HAY CREEK VALLEY EL PASO COUNTY, COLORADO CONSTRUCTION DOCUMENTS

DECEMBER 2023

PCD FILE #: SF2324
	BENCHMARK PROJECT ELEVATIONS ARE NAVD 88 ELEVATIONS BASED ON AN OPUS DERIVED ELEVATION ON CONTROL POINT 10, A NO. 5 REBAR HAVING AN ELEVATION OF 5769.92.		SEAL	HAY CREEK VALLEY
			PRELIMINARY THIS DRAWING HAS NOT BEEN APPROVED BY	EL PASO COUNTY, COLORADO CONSTRUCTION DOCUMENTS
, ү 	BASIS OF BEARING THE SOUTH LINE OF THE NORTHWEST QUARTER OF SECTION 22, TOWNSHIP 15 SOUTH, RANGE 65 WEST OF THE 6TH PRINCIPAL MERIDIAN, COUNTY OF EL PASO, STATE OF COLORADO, BEING MONUMENTED ON THE EASTERLY END BY A 2-12" ALUMINUM CAP STAMPED "NOLTE PLS25955 C1/4 S22 T15S, R65W 1999, "AND THE WESTERLY END BY	PREPARED BY: Matrix	GOVERNING AGENCIES AND IS SUBJECT TO CHANGE	TITLE SHEET
	A2-1/2" ALUMINUM CAP STAMPED "SSS PLS 16154 1/4 S21 S22 T15S, R65W 2000, "BEING ASSUMED TO BEAR S89°54'42"W, A DISTANCE OF 2,627.78 FEET.	Excellence by Design	FOR AND ON BEHALF OF MATRIX DESIGN GROUP, INC. PROJECT No. 22.886.076	DESIGNED BY:JAOSCALEDATE ISSUED:DECEMBER 2023DRAWING No.DRAWN BY:CVWHORIZ.N/ASHEET01OF 26TSO1CHECKED BY:JAOVERT.N/ASHEET01OF 26TSO1

FOR AND ON BEHALF OF	DESIGNED BY:	WCG	SC.	ALE	DATE ISSUED:	DECEMB	ER 2023	DRAWING No.
MATRIX DESIGN GROUP, INC.	DRAWN BY:	RWO	HORIZ.	VARIES				
PROJECT No. 22.886.076	CHECKED BY:	JAO	VERT.	N/A	SHEET	21	OF 26	DF02

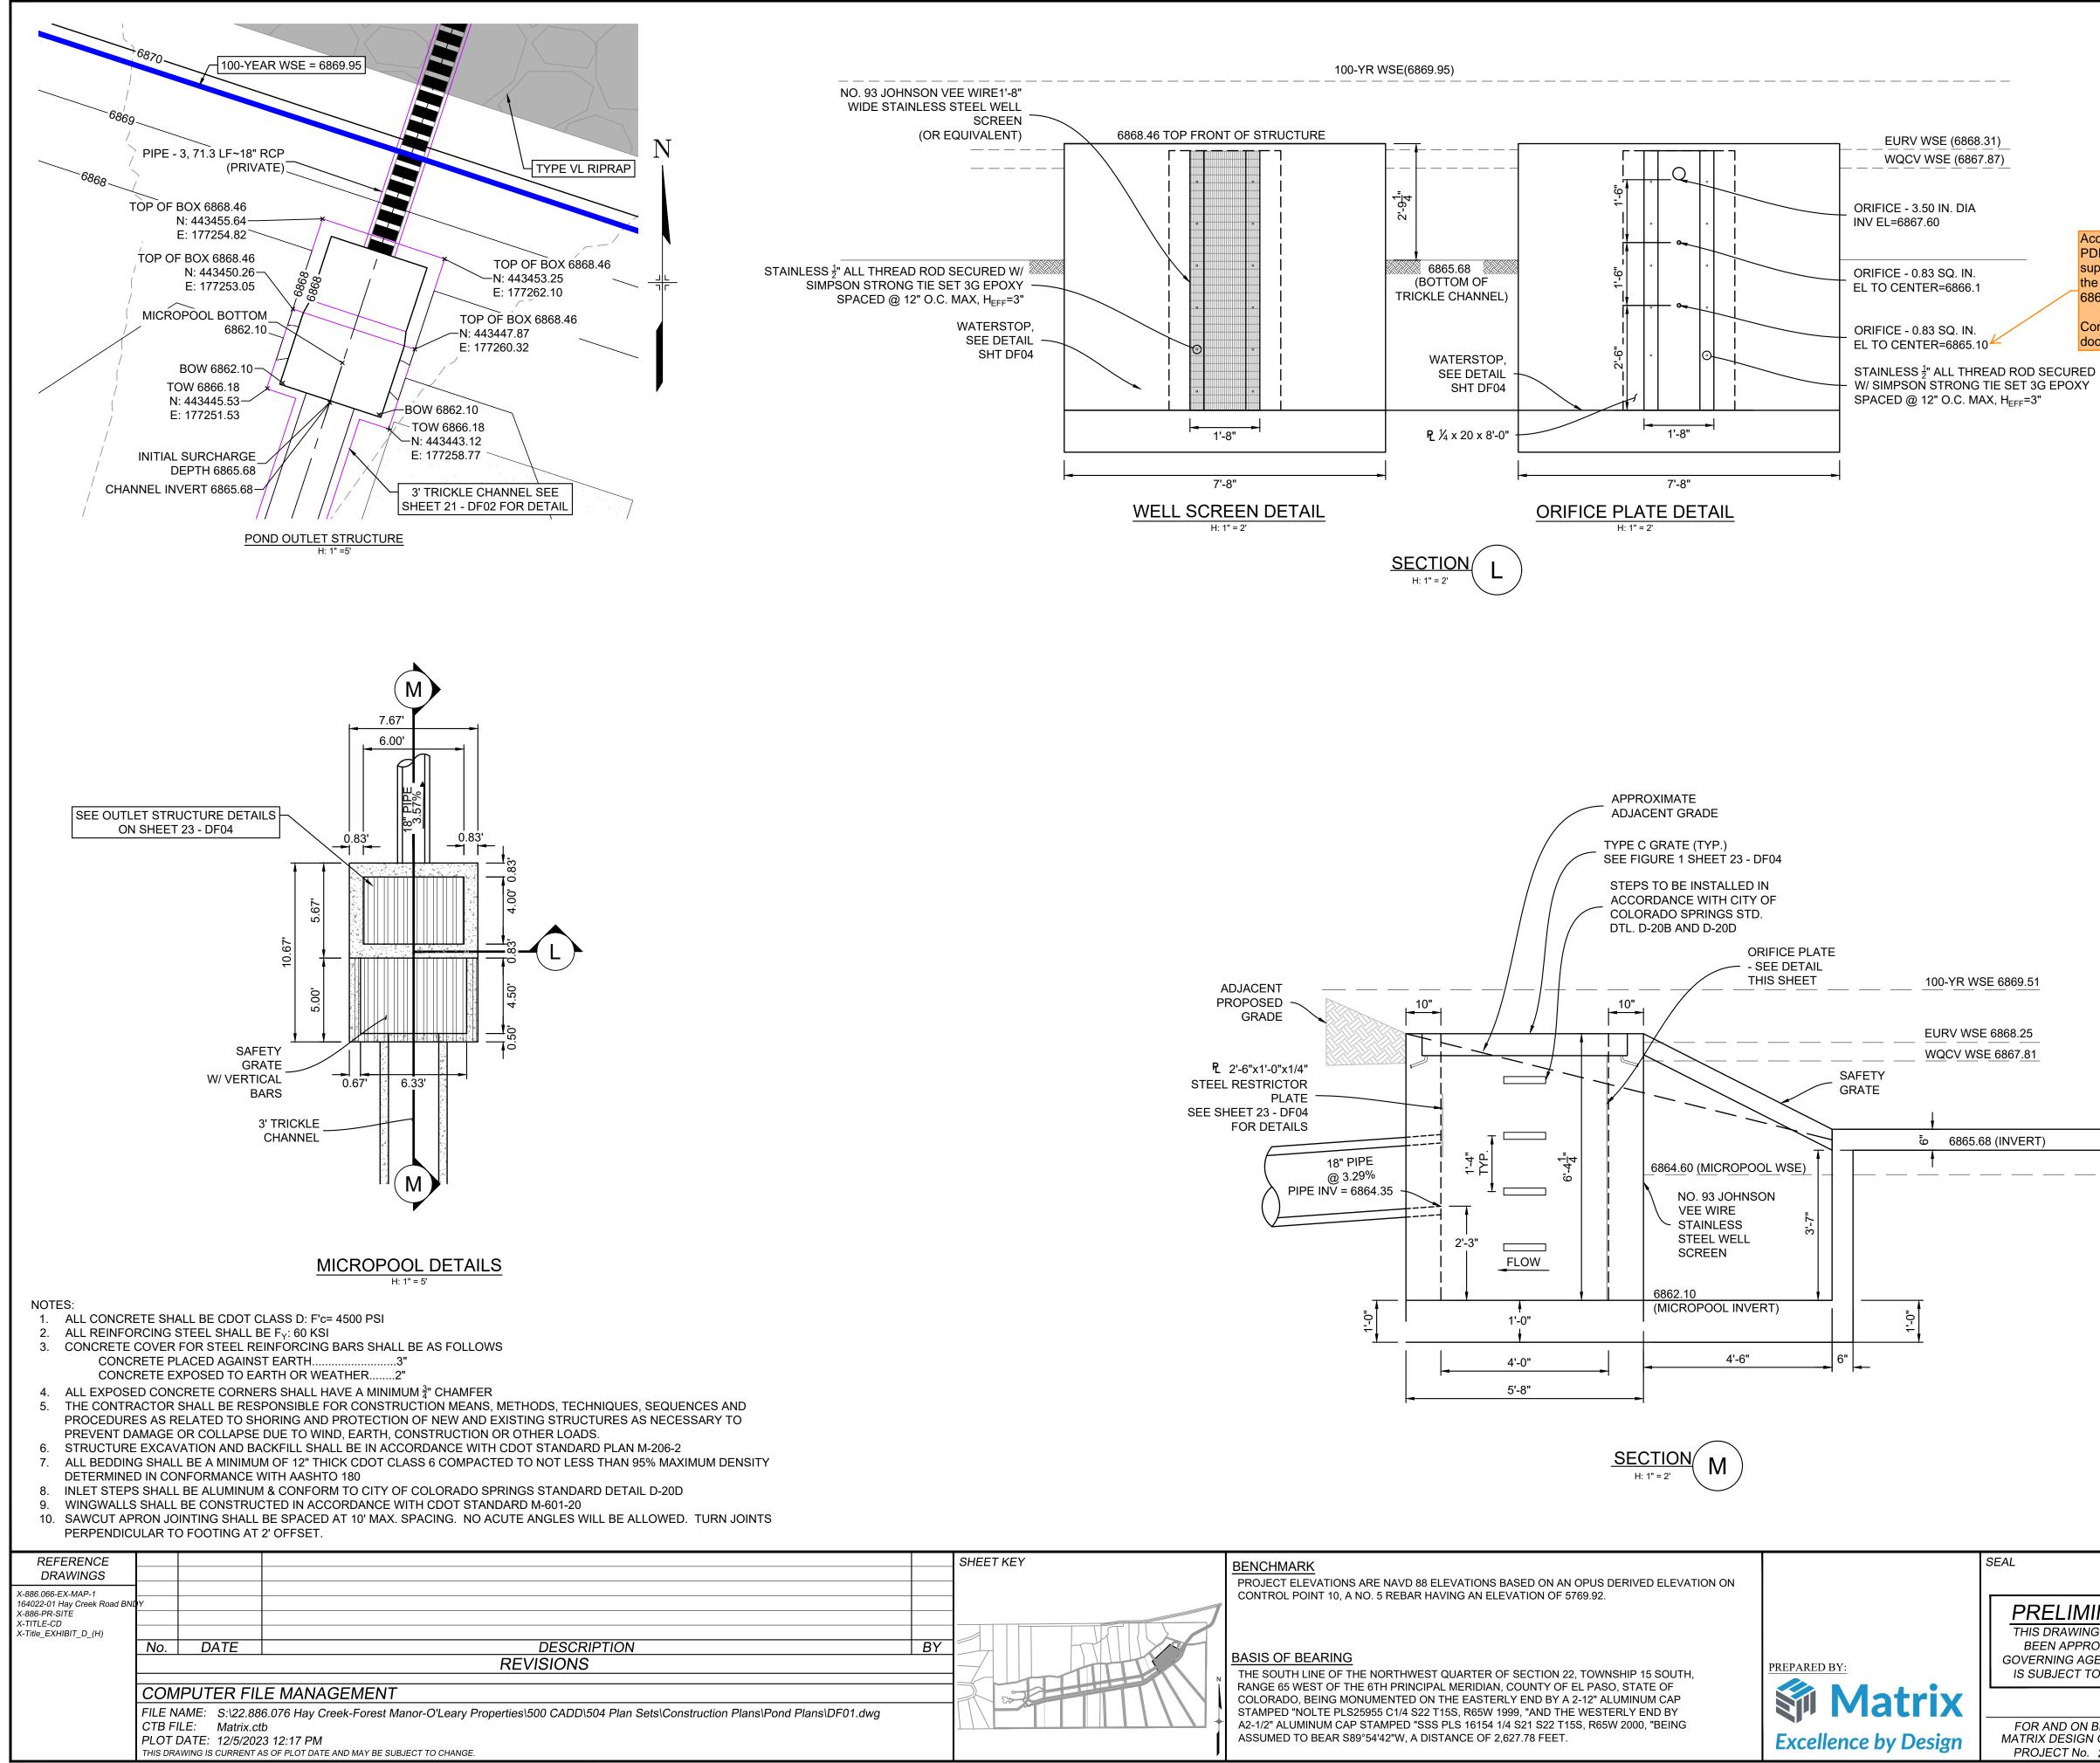
According to the MHFD-Detention spreadsheet on PDF pg 44 of the FDR, this centroid elevation is supposed to be at Stage = Oft which should be at the top of the WSEL of the micropool, which is at 6864.60ft

Comment generated due to changes in the document from previous submittal.
